PROPOSAL FOR DRAFT AMENDMENTS TO REGULATION No. 14  
(Safety-belt anchorages)

Addendum 1

Transmitted by the Expert from the International Organization of  
Motor Vehicles Manufacturers (OICA)

Figure 1

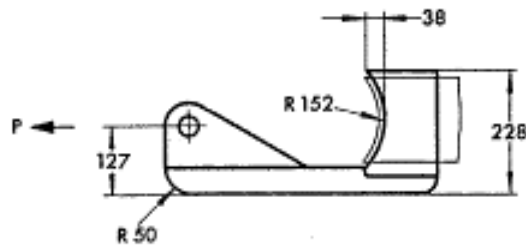
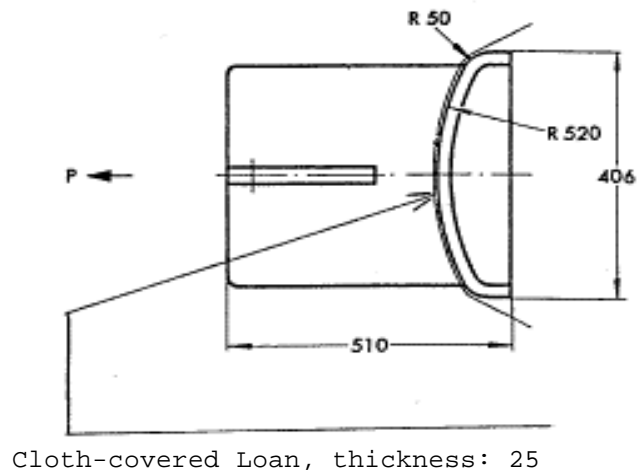
Annex 3, amend to read:
